**Program Environmental Impact Report
Morena Corridor Specific Plan
San Diego, California**

**Project No. 582608
SCH # 2016101021**

FINAL PROGRAM ENVIRONMENTAL IMPACT REPORT

RESPONSE TO COMMENTS

Improvement 17: Vacate Metro Street

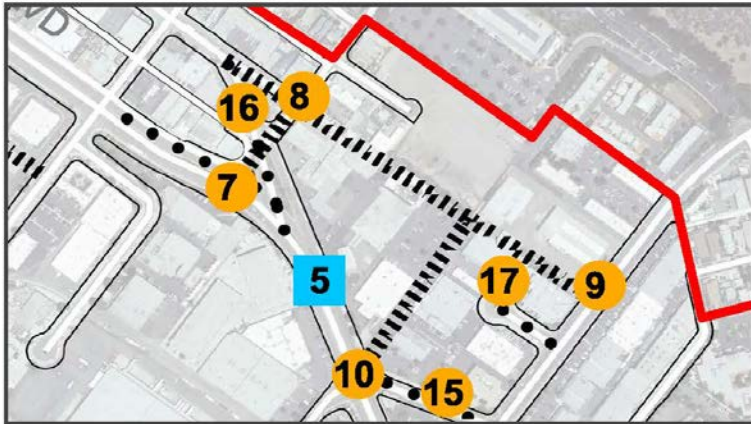
- As part of the proposed improvements, a segment of Morena Boulevard will be closed/vacated to allow for the re-establishment of a more typical street grid, and accommodate other proposed improvements to improve mobility for all modes.
- Morena Boulevard will be closed from where the extension of Morena Boulevard begins to West Morena Boulevard. Cushman Avenue extension bisects this vacated segment.

- Vacate Metro Street north of Linda Vista Road to minimize the number of intersections along Linda Vista Road.
- Implement this improvement concurrent with the extension of Morena Boulevard.

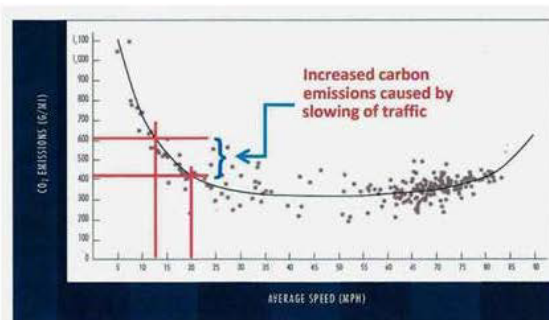
BO-25 Below is a graph of the GHG production of average cars versus vehicle speed. VMT does not address the issues of either reduced traffic speeds as well as gridlock. LOS analyses provide only the barest relation to true GHG production covering at best only normal idle time creation. Most analyses ignore them altogether.

BO-24 Comment noted. This comment does not suggest an inadequacy in the analysis of the PEIR.
